A G E N D A

Architectural Review Board

January 24, 2023 – 5:30 p.m.

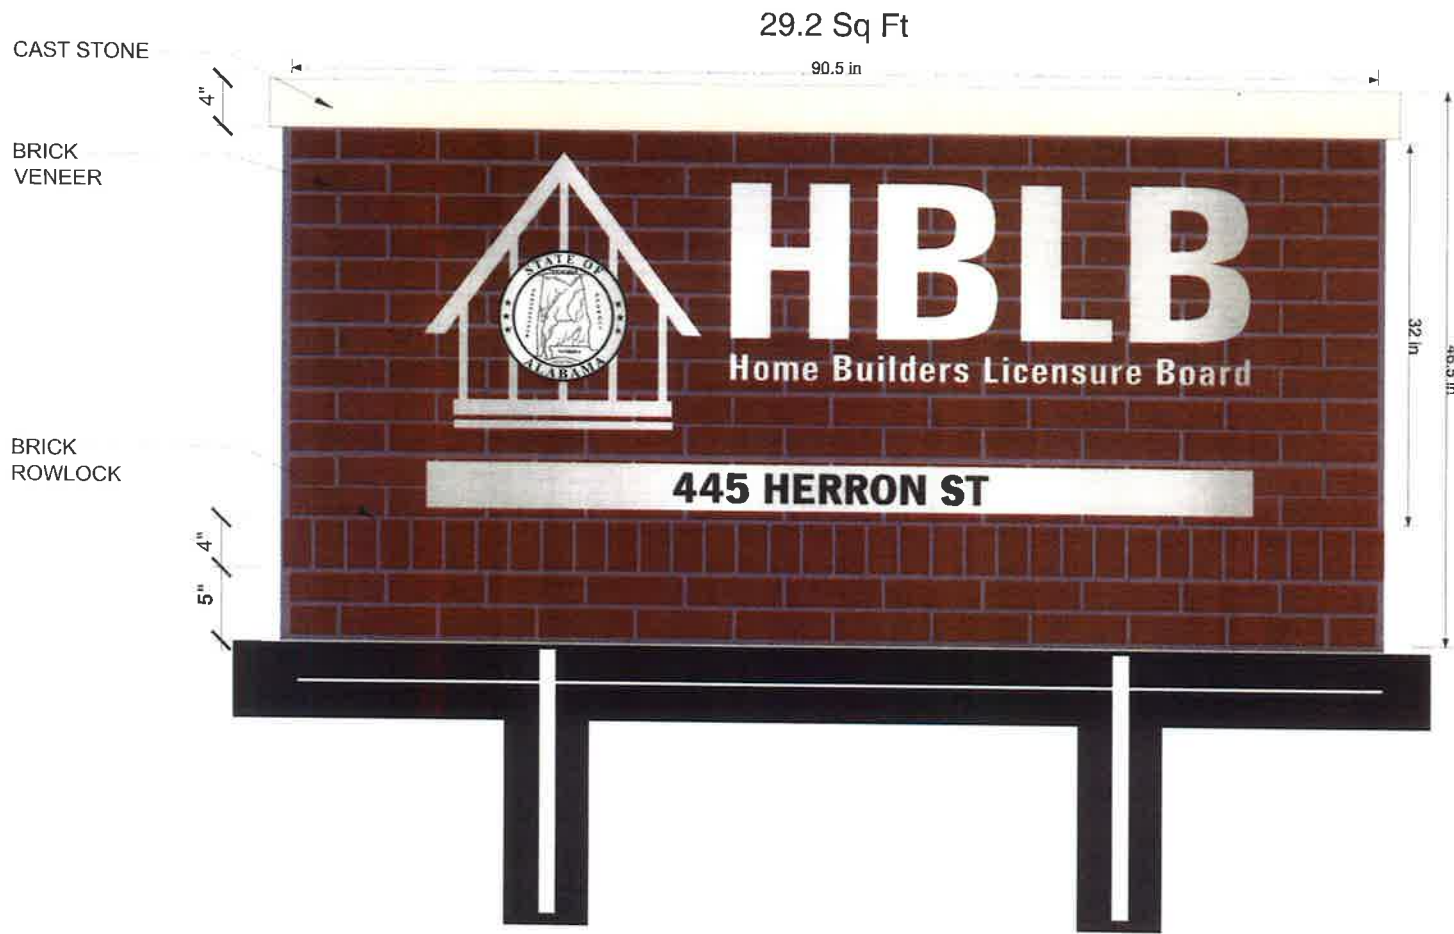
- This item was delayed at the last ARB meeting due to no one being present.
- One street view image shows the previous ID sign; a second shows a sign on a 4'x8' board in approximately the same location and orientation as the proposed sign. The monument is similarly sized, but will be set on the ground.
- The actual sign face is about 20SF, meets lighting guidelines, and with landscaping will only further screen the view of the parking lot. No objection.

1200 S Lawrence
Front porch floor area

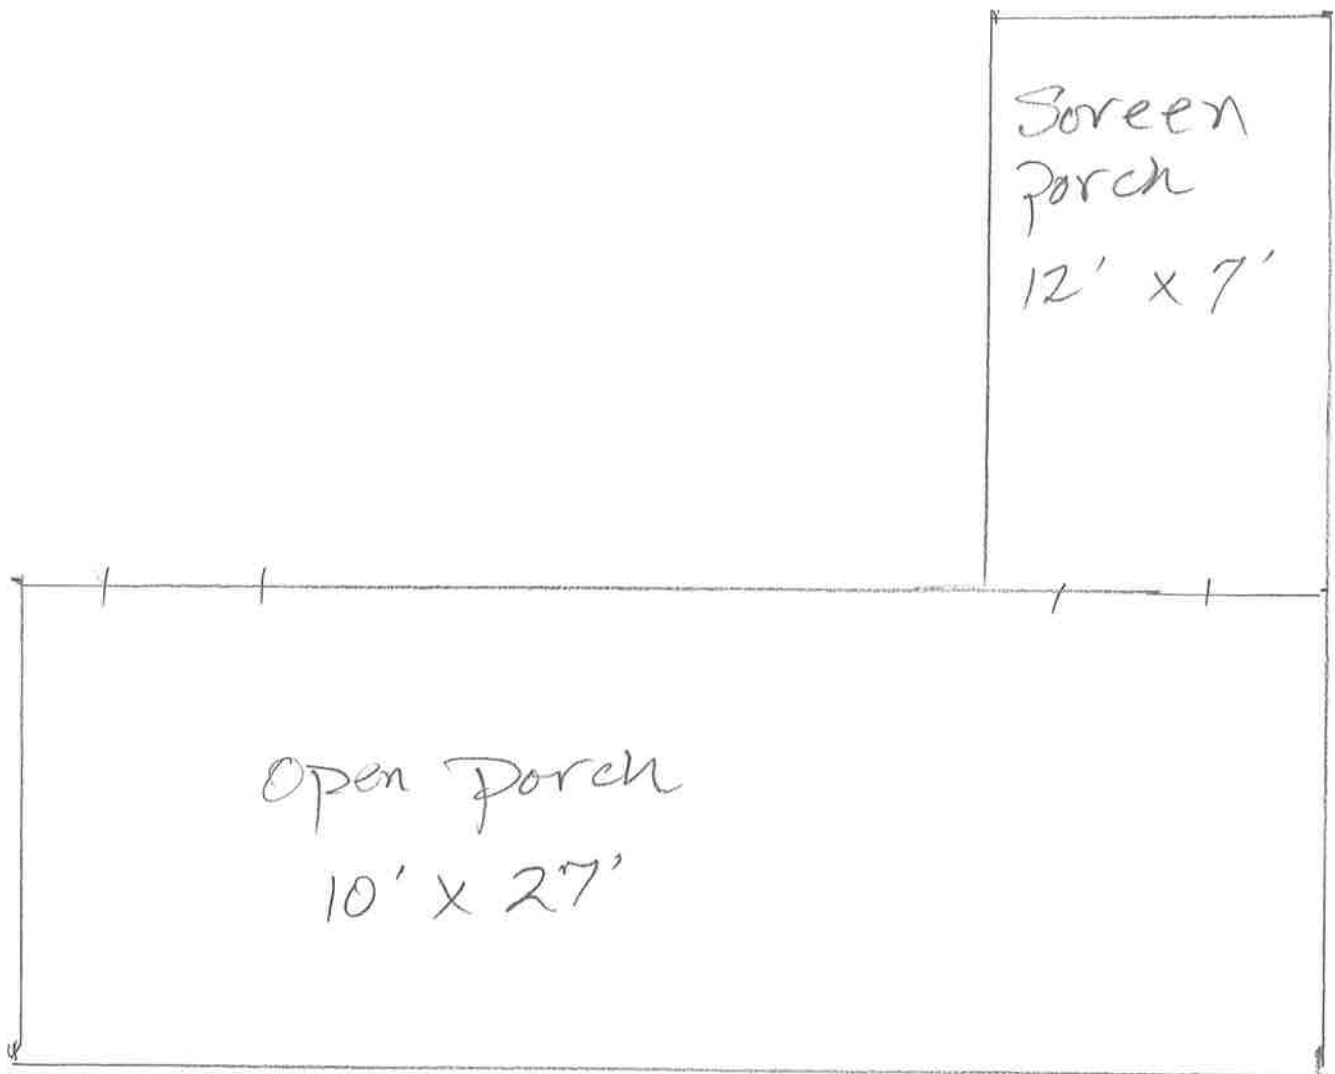
REMARKS: The petitioner is requesting permission to replace the deteriorated tongue and groove hardwood porch flooring with tongue and groove cementitious hardboard. The flooring will be Deckorators, kettle color. A sample will be provided by the petitioner at the meeting.

- This item was carried over due to no one being present.
- No objection.

735 E. Fairview Avenue, Cloverdale 6/10/22

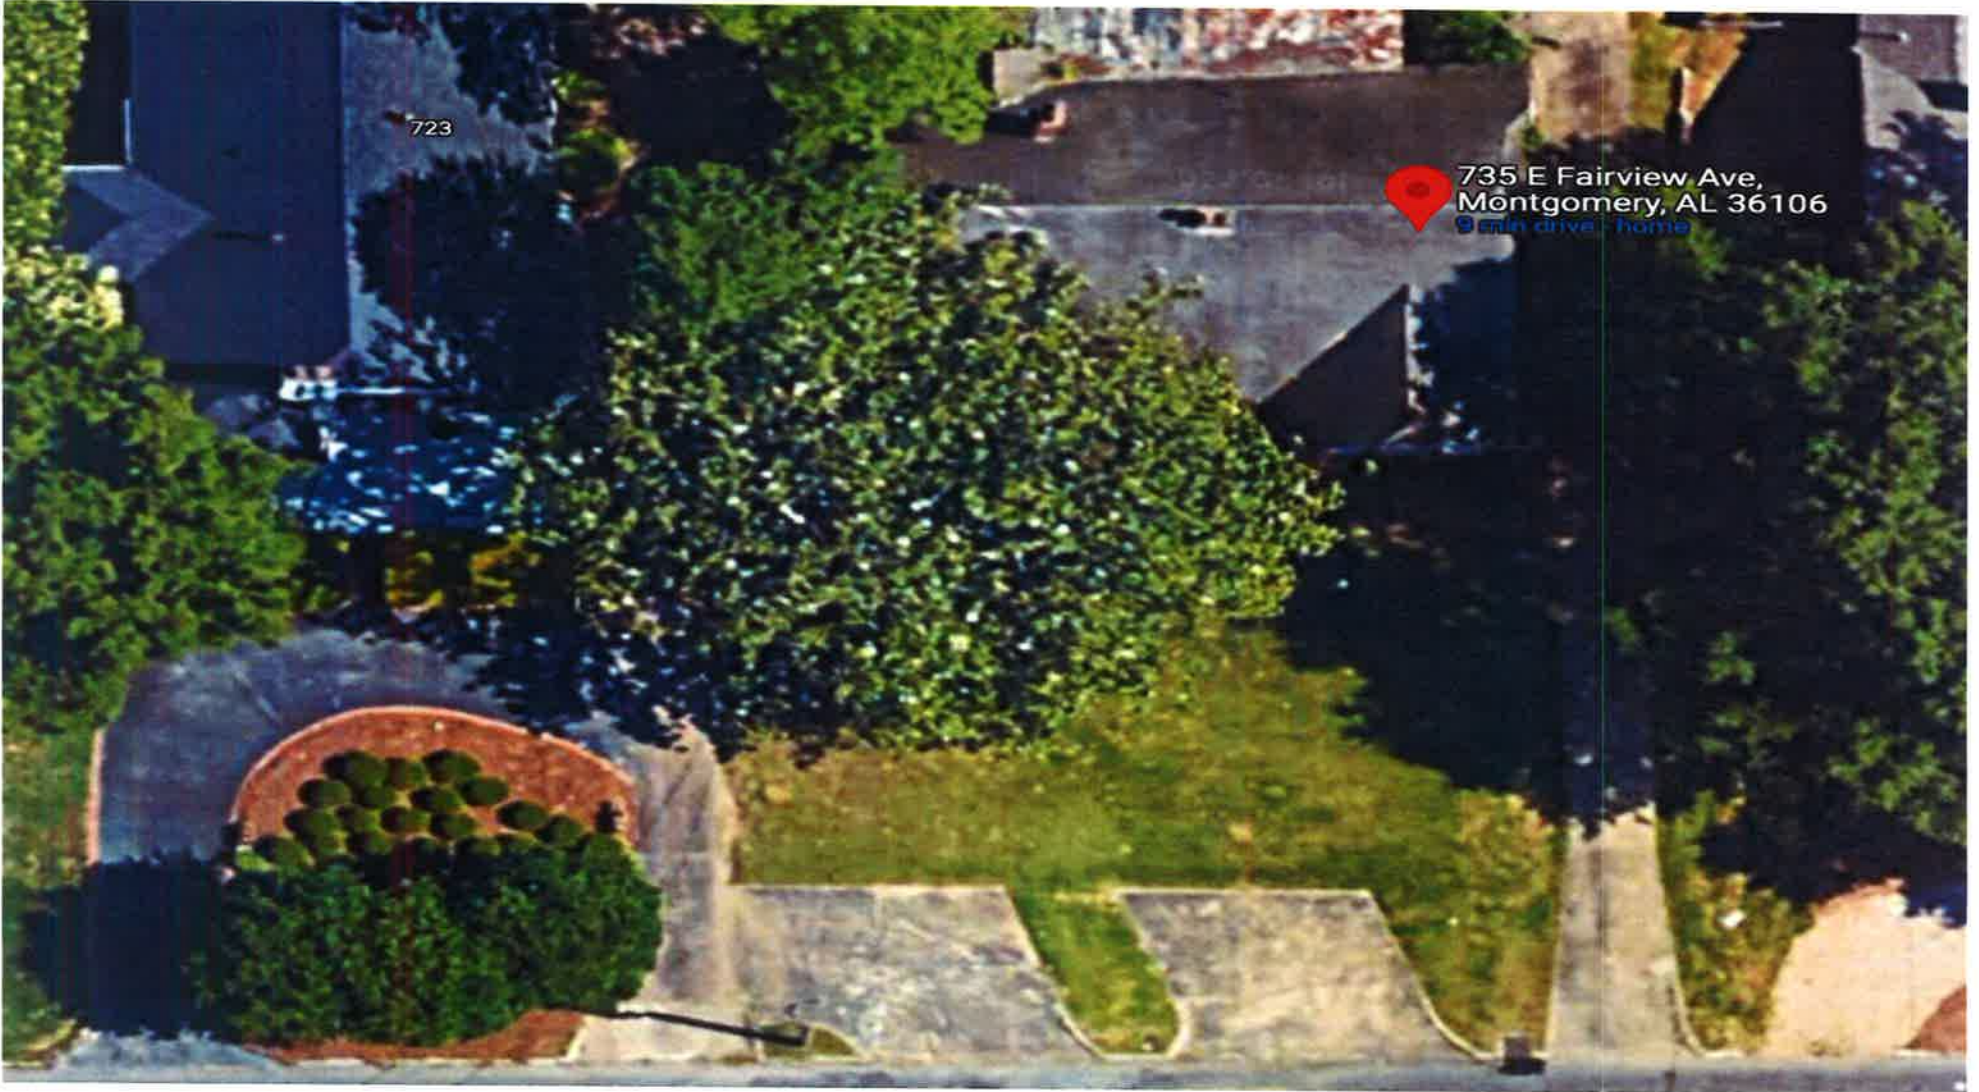
- The question for the Board with violations is always “Would we have approved this project as presented if the petitioner had asked first?” Just because it is there doesn’t mean it has to stay there as is.

- The situation is always evaluated on a case by case basis as well as considering whether a differently executed plan would yield a similar result. This property has a driveway that goes behind the house to a garage, which offers some off street parking.

- The parking area has been pulled over to be out of the line of sight of the front door.
- Gravel should be clearly contained so it cannot spill into the street.

- When parking areas have been approved, they had to be able to provide enough screening from the street to soften the view of the parking area from the street. Parking area, if approved, should have a screen planted along the Fairview edge of the property and not present a continuous sea of gravel on the east half of the front lawn to the front property line. That will still afford the opportunity to not have to back out onto Fairview. Installed landscaping does not appear to meet the landscaping guidelines of evergreen shrubs, 18” high at installation, spaced 36” on center.

Proposed Fence

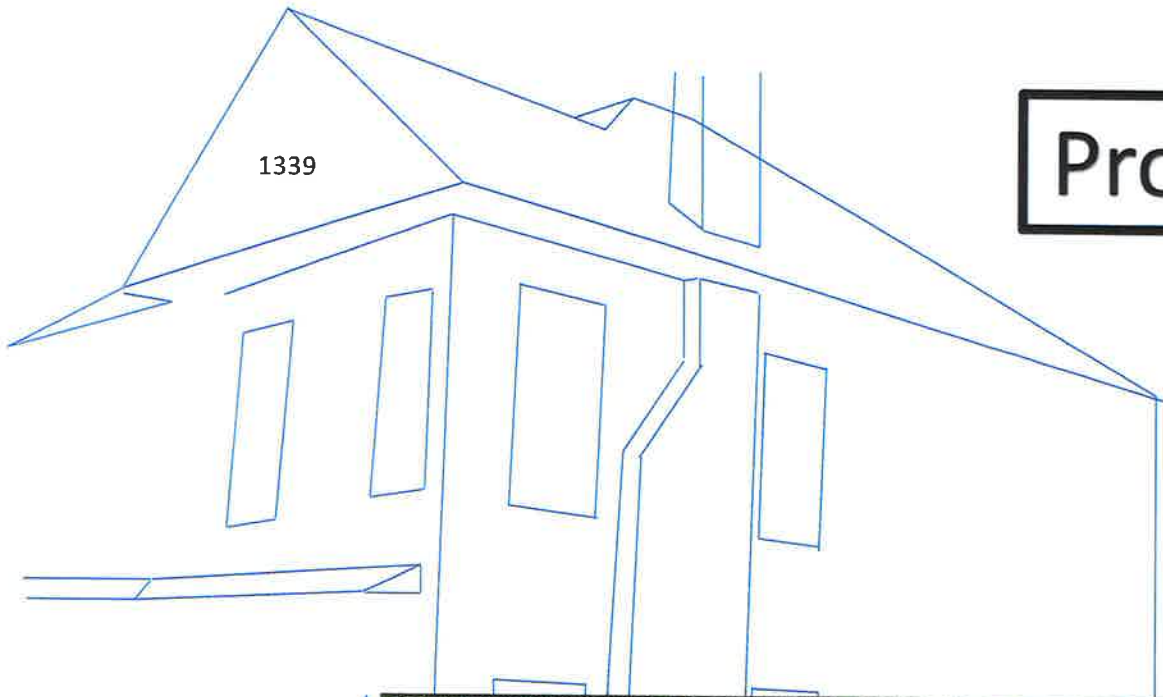
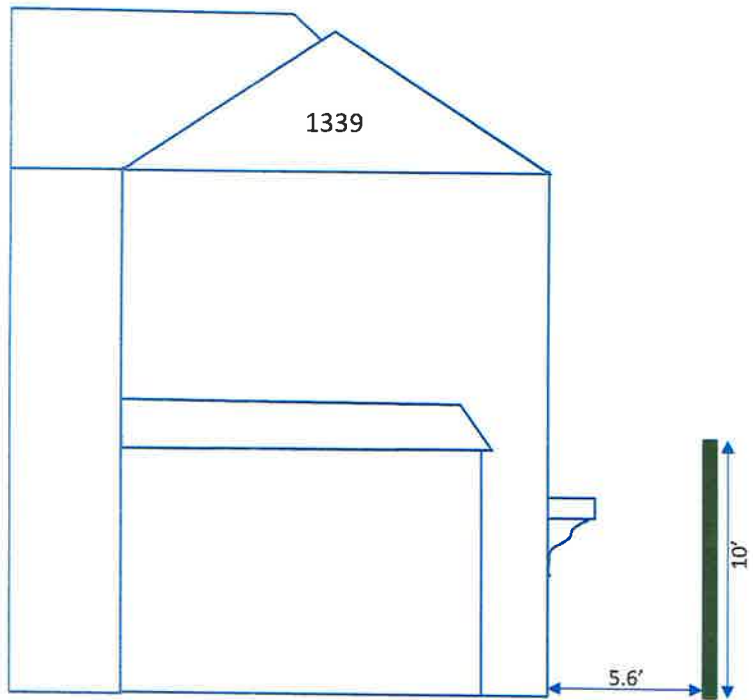
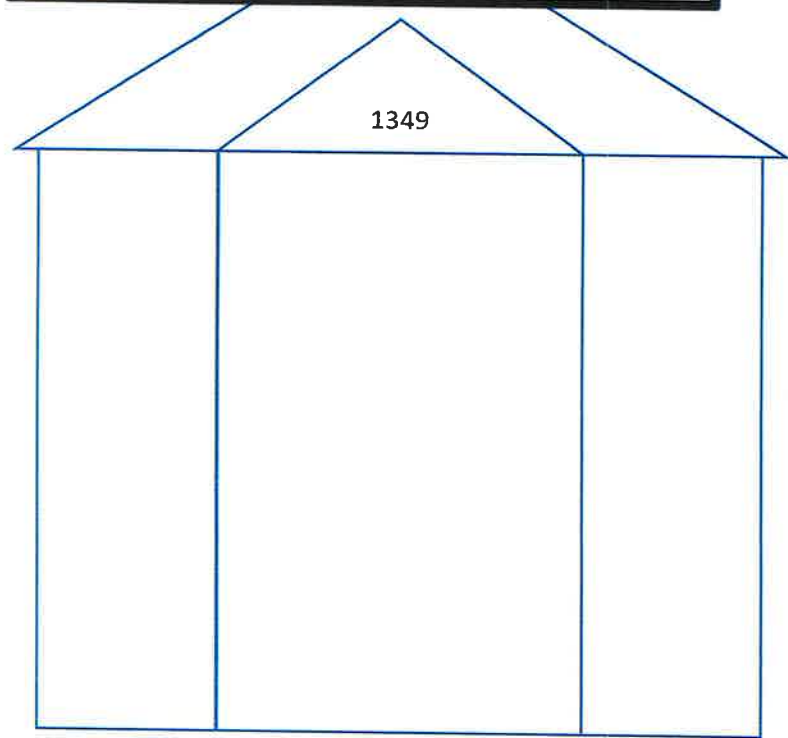
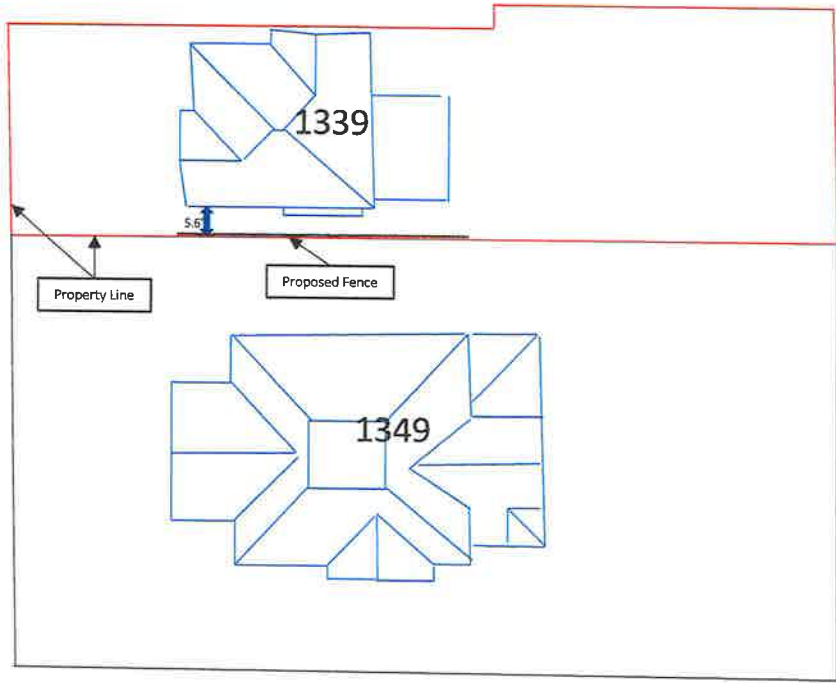
- The guidelines call for privacy fences not to exceed 6 ft. in height. The Board has approved fences that have been up to 10 ft. tall when warranted. The "situation" has generally been caused by a change in grade between two properties where a 6 ft. fence would be ineffective.
- The fence is proposed only along a portion of one property line, and will not enclose the entire rear yard.
- A variance from the Board of Adjustment will also be required.
